# **Submissions Report**

**No Fuss Liquid Waste Pty Ltd**

**June 2012**

**Project No: 3439.001**

Figure 2 –  
Existing Odour  
Treatment System

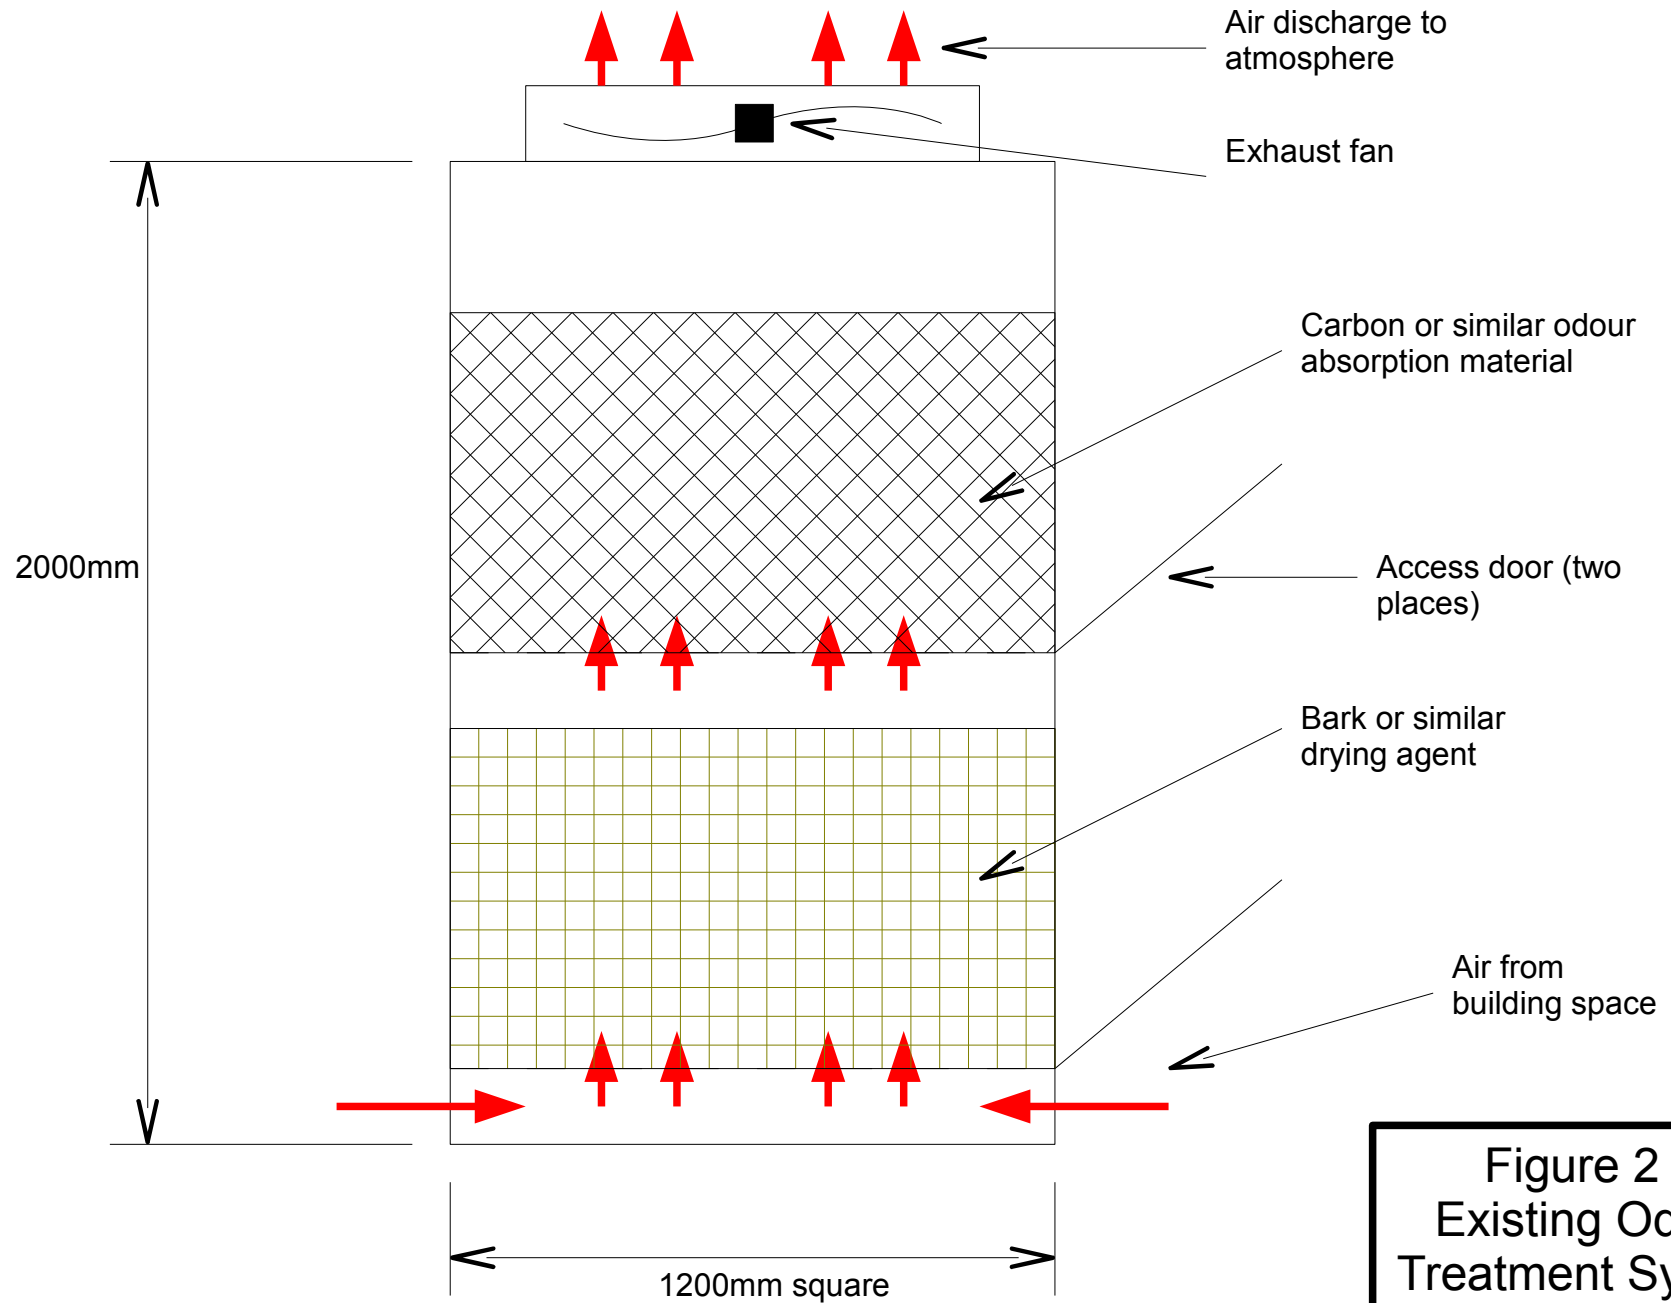
- These locations are readily managed with suitable hoods to collect odorous air.
- **Odour Treatment System**
  - A simple system for collection of air within the building space and treatment prior to discharge to atmosphere was observed. The basic arrangement is shown in Figure 2.

- **Odour Treatment System**
  - Modify the existing odour treatment system to that shown in Figure 5
    - Create two granular activated carbon beds using 20 litres pillows (6 off pillows per bed)

FIGURE 4  
DUCTING ARRANGEMENTS

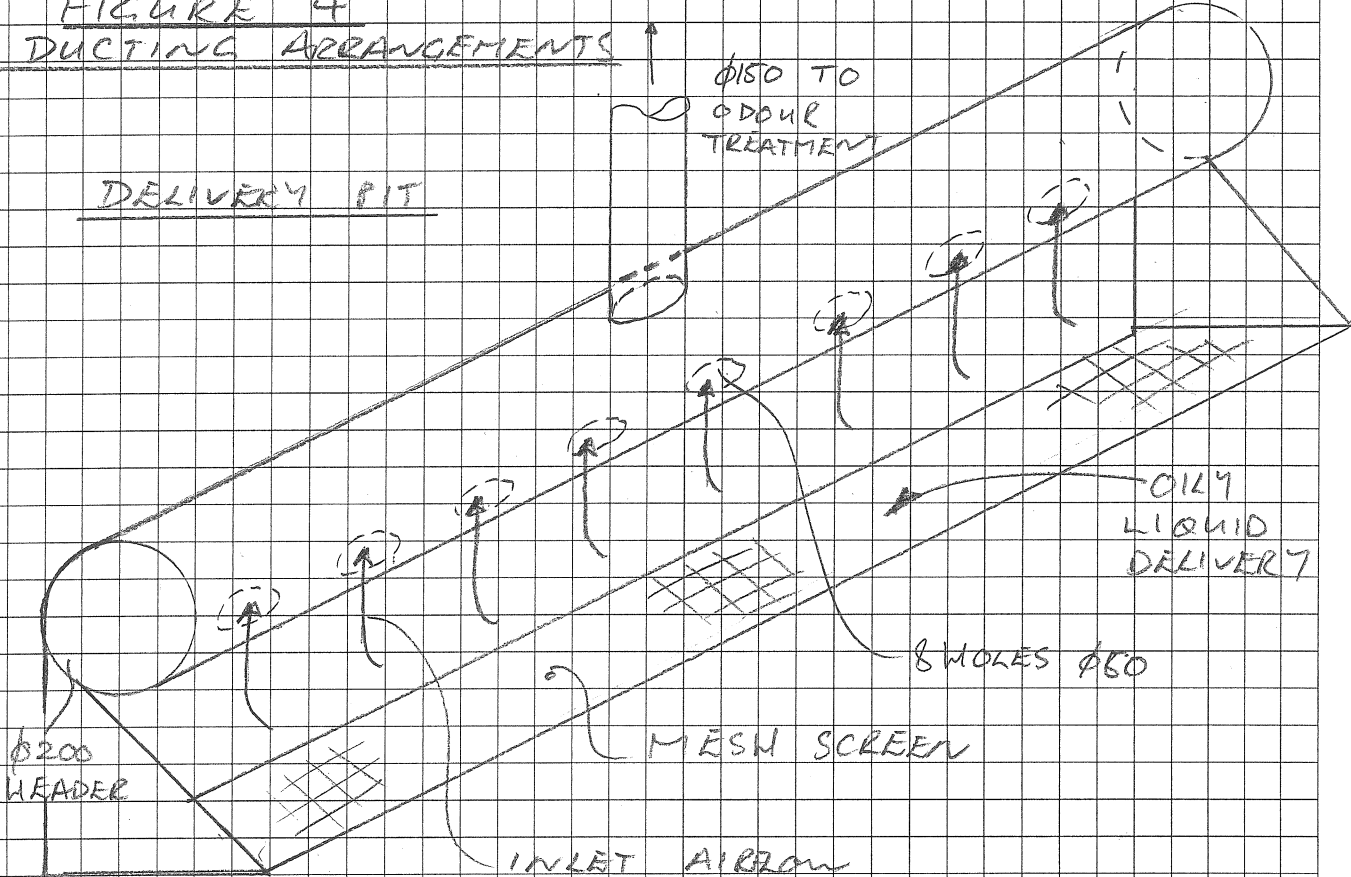
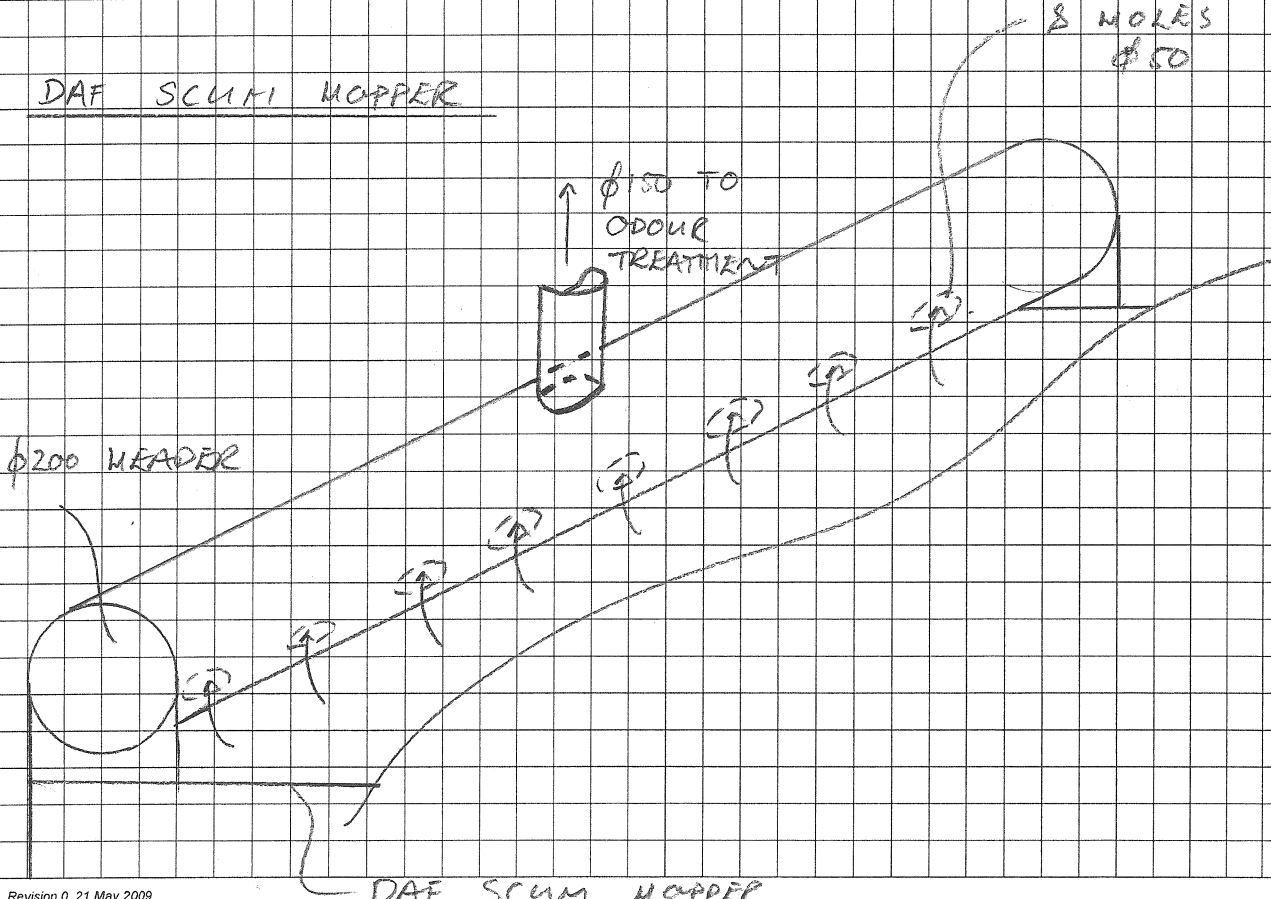
- The mesh screen should be installed within an air extraction hood, which may require some reconfiguration of the existing screen. The hood should be fitted with a manifold with 8 holes each 50mm diameter. A sketch of the arrangement is shown in Figure 4.

- Construct a hood over the scum collection chamber, similar to shown in Figure 4. The hood should be fitted with a manifold with 8 holes each 50mm diameter.
